STATE OF WEST VIRGINIA

Hampshire HEALTH DEPARTMENT
ON-SITE SEWAGE DISPOSAL SYSTEM
INSPECTION FORMPermit No.: ST-14-06-496Tax Map: 4 Parcel #: 64County Road: Jenney Mountain

Sketch of Installation with Triangulation or Distance to Specific Landmarks:

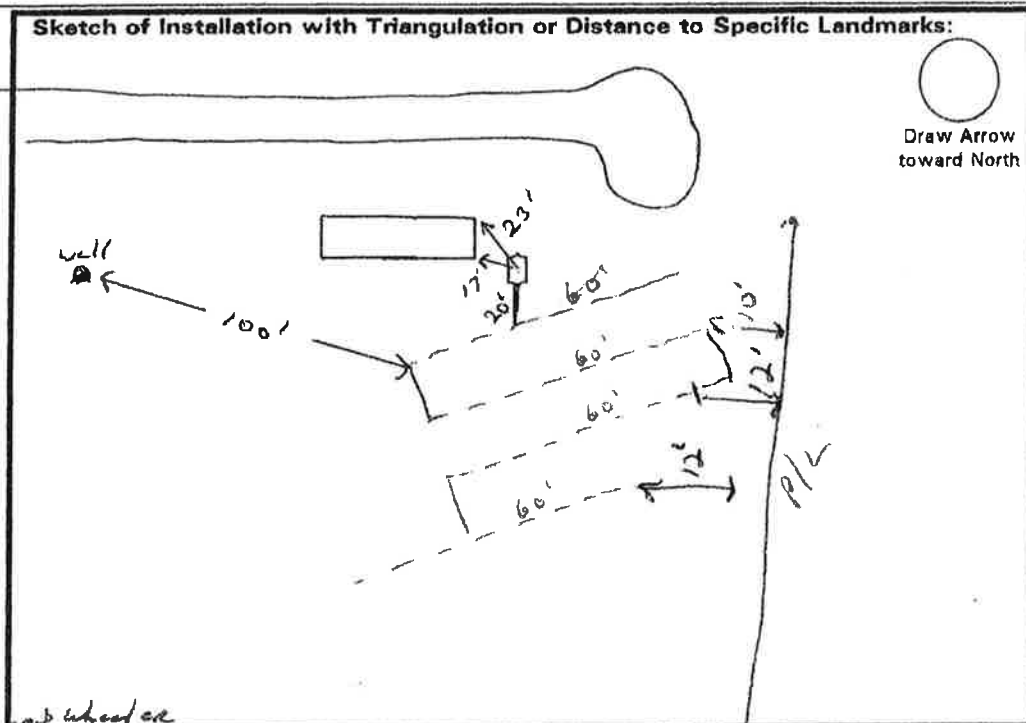
Approved and Adequate Materials Used? Yes (☒ No () Size Equates to: 1200 Square Feet of Standard Gravel FieldDistances (in feet) of System to: Dwelling: 25 Private (☒ Public ()) Water Source: 100 Property Line: 10'Remarks: One chamber removed from Lines 2, 3 + 4 to obtain min. Distance to property line
